TEXAS  
COMMISSION  
ON ENVIRONMENTAL  
QUALITY

**PERMIT NUMBER: WQ0015314001**

Randolph Todd Company, LLC  
TPDES Water Quality  
Permit No. WQ0015314001

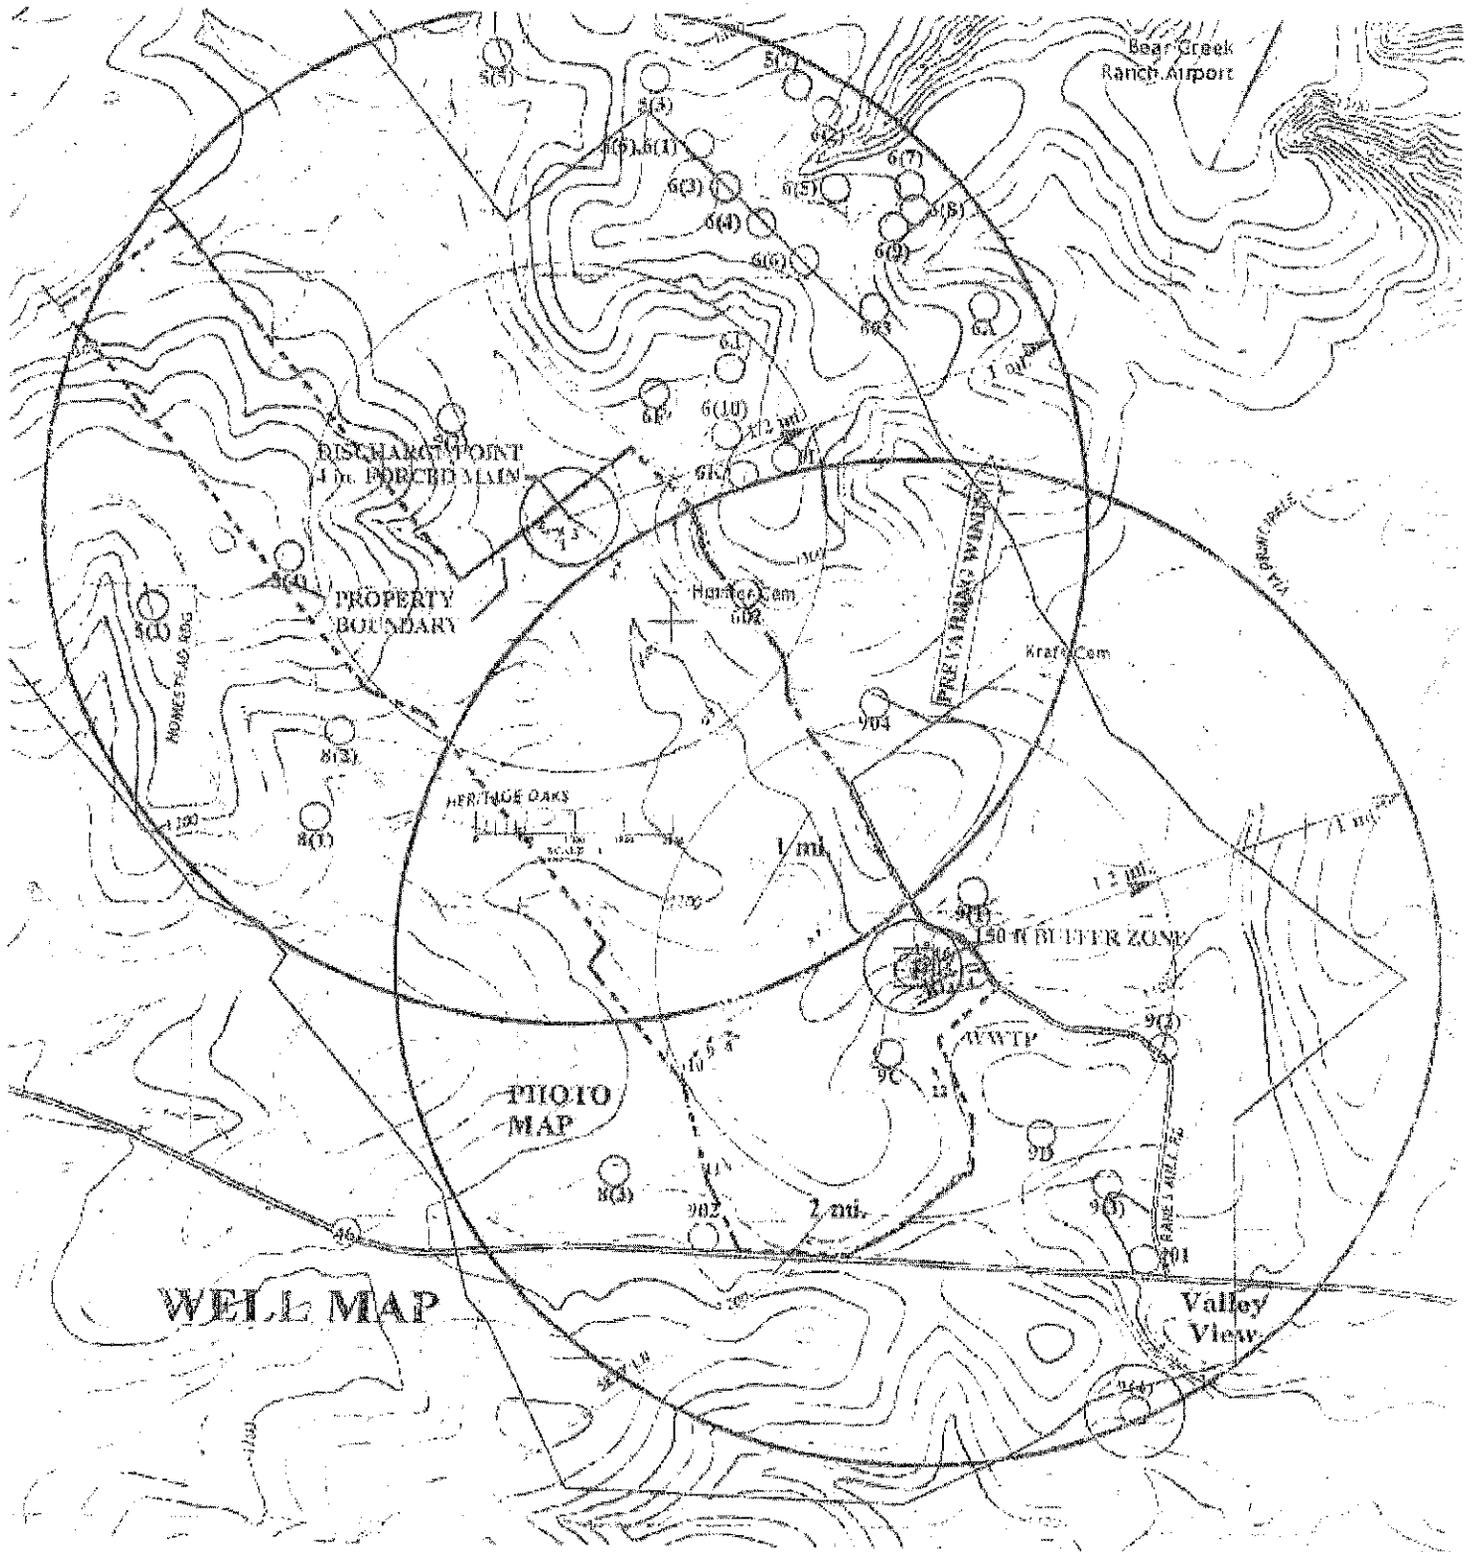
**COMMENTS:** I found the application to be incomplete and many errors relating to the flow of Dry Comal Creek. Each page of this was signed by a certified engineer and they should be given notice of incomplete workmanship or fined. If the commission is expect to rule on an application then it should be technically correct. All the people that checked this and review the application should be chastise. Why should the people

fighting the application have to correct the errors. Please see attached PDF for major errors on how the creek flows and what bodies it flows into.
